INDESIT company

Model type:
AVTL109EU

Commercial code:
F033199

General notes

1140960 Exploded views

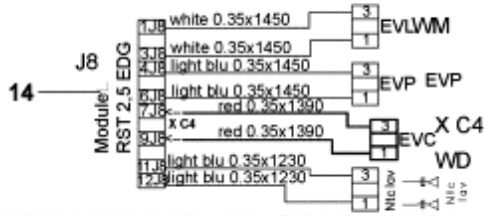
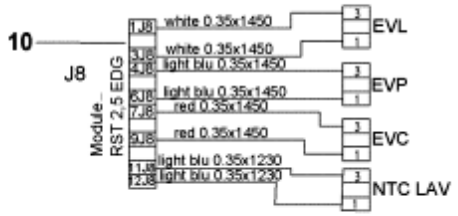
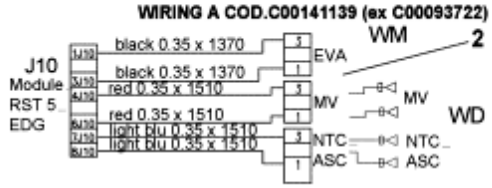
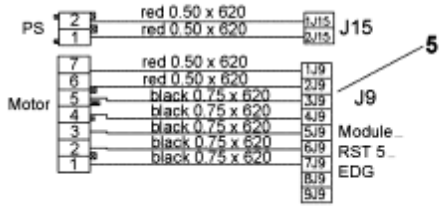
The new wiring when fitted, must be securely attacched to the machine wiring with insulating tape. **Matr. 61116.0001**

WIRING P = DRUM BLOCK COD. C00141995

WIRING P = DRUM BLOCK COD. C00112822

n1040345: Replacement of drum lock button TL EVOII.

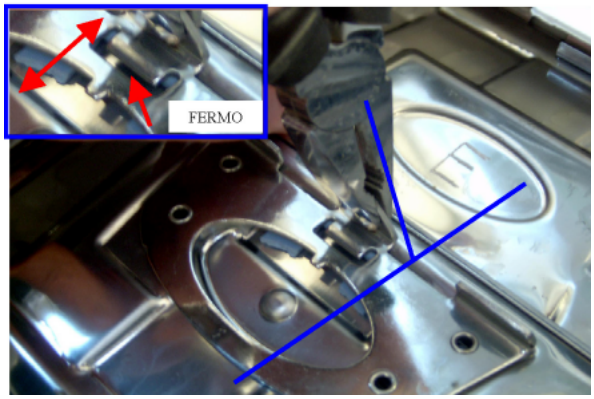
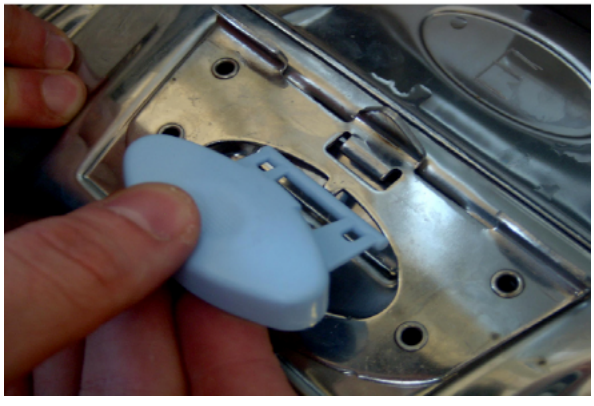
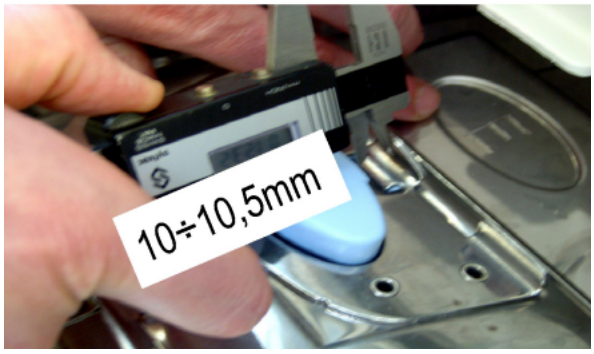
Tools and material needed: pliers, screwdriver, gauge, spring P/N Sat 114989, button P/N Sat 114990.

1) turn the central tip of the catch in the direction shown (FIG.1);

2) bring the tip to a vertical position and ensure that the broken button is disengaged from the catch restraint and can be removed (FIG.2);

3) remove the remaining part of the button with the aid of a screwdriver, taking care not to scratch the doors (FIG.3);

4) pre-assemble spring to button (FIG.4);

5) insert button between catch and door (FIG.5);

6) bring the button into position and arrange the spring in its location in the door (FIG.6);

7) turn the central tip of the catch in the direction shown to return it to its starting position (FIG.7);

8) check the distance between button and catch (FIG.8);

9) check correct operation of the button when opening and closing the doors (slight inclination errors of the catch can result in faulty closing of the doors) (FIG.9).

n1040388: 3.5 three phase module introduced - top-loading Brembate

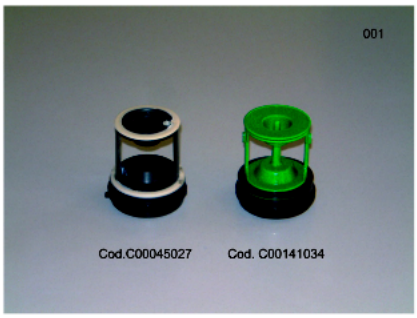
From serial no. 51020.0001 a new 3.05 three phase module has been introduced.
The modification affects the following parts:
-module
-eeprom
-cables (for washing machine with tub lock only)

New parts:
C00265676 three phase module 3.5 - for models with conducibility sensor
C00254298 three phase module 3.5 - for models without conducibility sensor
C00141995 - tub lock cables

Premodification parts:
C00108982 - three phase module
C00112822 - tub lock cables

The spare parts warehouse is not managing the premodification module C00108982, so the new 3.5 C00254298/C00265676 can be fitted on the premodification models using the new setting file the new tub lock cables (on products with tub lock).

ATTENTION!! USING THE NEW MODULE ON PREMODIFICATION MODELS, WHEN YOU DOWNLOAD THE SETTING FILE WITH PALM YOU MUST SELECT A SERIAL NUMBER AFTER THE MODIFICATION.

n4008f00: Thermic link wire removed on three-phase motor

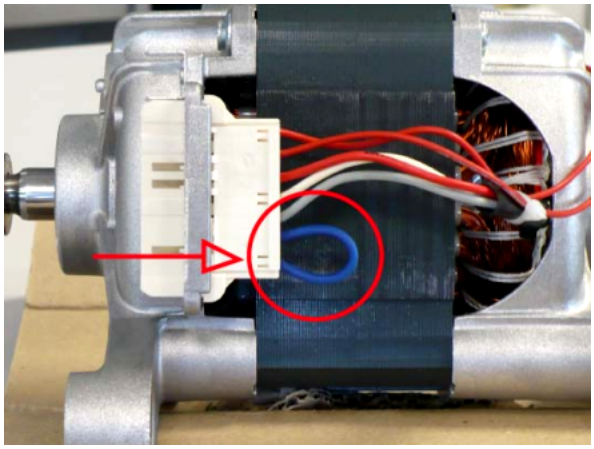
Attention!
When you assist the premodification models using the new motor code you MUST use the thermic link wire code C00265838.

The spare part warehouses will manage the premodification motor until the end of the stock, after they will be replaced with new ones and thermic link wire.

TRIPHASE P32 46 L TOP LOADING
C00265832 new motor without thermic link wire - C00262375 premodification motor with thermic link wire

In the attached image you can see the fixing of thermic link wire in the motor therminal box.
